RESPONSE TO REQUEST FOR ADDITIONAL INFORMATION

APR1400 Design Certification

RAI No.: 203-8214
SRP Section: 08.03.01 – AC Power Systems (Onsite)
Application Section: 8.3.1
Date of RAI Issue: 09/08/2015

Question No. 08.03.01-18

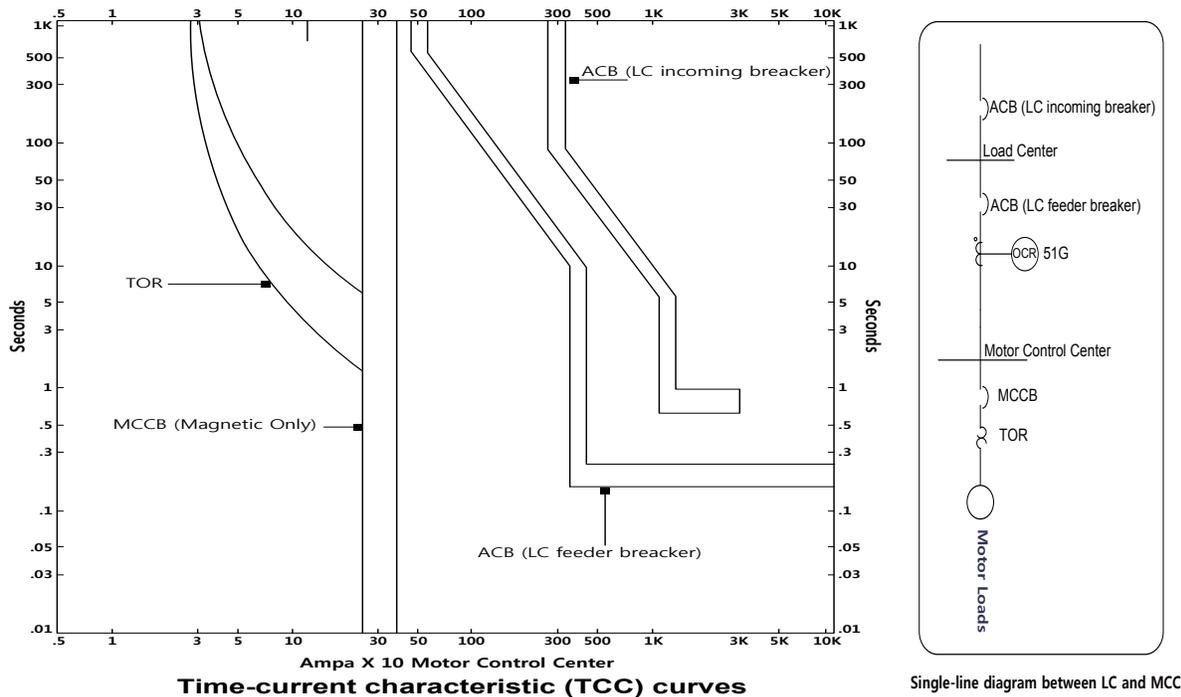
The single line diagrams, Figures 8.1-1 and 8.3.1-1, show one circuit breaker as the connector between the load center and the motor control center (MCC) as typical. GDC 17 states that onsite power systems shall provide sufficient capacity and capability in the event of postulated accidents. Please clarify why an incoming breaker (Main Disconnect) at the MCC is not provided for protection of the MCC. Otherwise, please discuss how protection of the MCC with selective protection coordination is achieved from electrical faults.

KHNP does not place incoming breakers at the motor control centers (MCCs) because of the inherent characteristics of molded case circuit breakers (MCCBs) used, which trip instantaneously when fault current flows through the MCCB.

In order to enable selective protection upon a fault at the MCC feeders, the 480V load center (LC) feeder breakers and the 480V MCC feeder breakers are properly coordinated such that the circuit breaker nearest to the fault location clears the fault before the upstream circuit breakers.

The 480V LC feeders including the MCC main buses are protected by the LC feeder breakers, air circuit breaker (ACB) type, whose trip device is equipped with long time (LT) and short time (ST) trip elements of the overcurrent relay. For ground fault protection, the ground overcurrent

relay (51G) and ground sensor (50GS) provide protection for the feeder to the 480V MCC and to a LC single load.

The 480V MCC feeders are protected by the MCC feeder breakers, which are two types of MCCB; one is magnetic-only (MO) type and the other is thermal-magnetic (TM) type. The MO type with the overload relays, magnetic contactors, and motor starters is used for motor loads and the TM type is used for non-motor loads such as transformers, heaters, and receptacles, etc. The ground sensor (50GS) is also provided for ground fault protection according to the capacity and location of the load.

The MO type MCCB or TM type MCCB provides primary protection for the MCC feeders with instantaneous and overload (with time delay) protection characteristics.

The ACB which has LT and ST trip elements of the overcurrent relay provides primary protection for the MCC main bus and also backup protection for the MCC feeders. The ACB protection elements are designed to properly coordinate with the primary protection of the MCCB such that the selective protection coordination precludes nuisance trips of the LC feeder breaker upon a trip at the MCC feeders. To illustrate the preceding, an example of the time-current characteristic (TCC) curves with a single line diagram between the LC and MCC is provided below.
